To: T10 Technical Committee
From: Rob Elliott, HP (elliott@hp.com)
Date: 1 December 2004
Subject: 04-370r1 SAS-1.1 Merge IT and IR with XT and XR

Revision 1 (1 December 2004) Incorporated comments from November SAS Physical WG. Updated all the figures to use transmitter/receiver circuit/device terminology and show where test loads are applied. Separated the concept of transmitter device testing and receiver device tolerance testing.

Figure 12 — Deriving a receiver device jitter tolerance eye mask at IR, CR, or XR

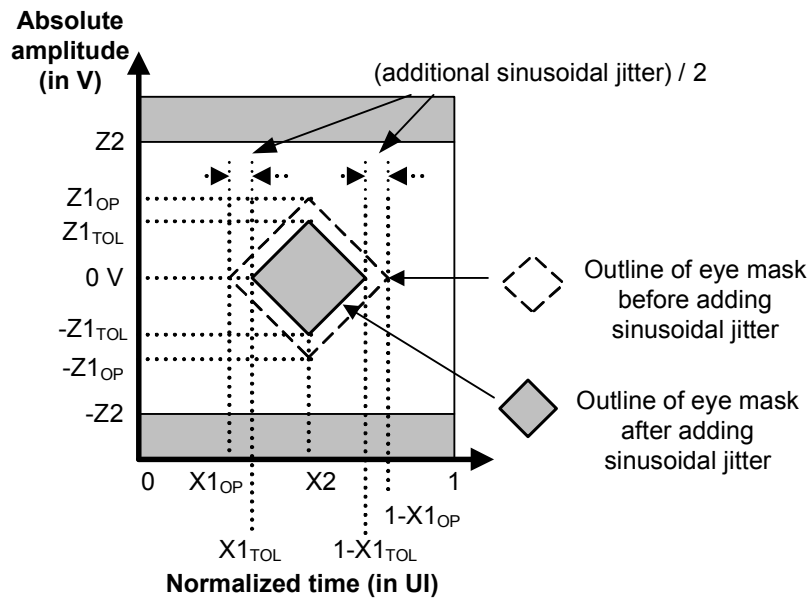
Figure 12 describes the ~~receive tolerance eye masks at IR, CR, and XR and eye mask used to test the jitter tolerance of the receiver device at IR and CR.~~ Figure 12 shall be constructed using the X2 and Z2 values given in table 4. X1_{OP} shall be half the value for total jitter in table 8 and X1_{TOL} shall be half the value for total jitter in table 10, for applied sinusoidal jitter frequencies above ((bit rate) / 1 667).
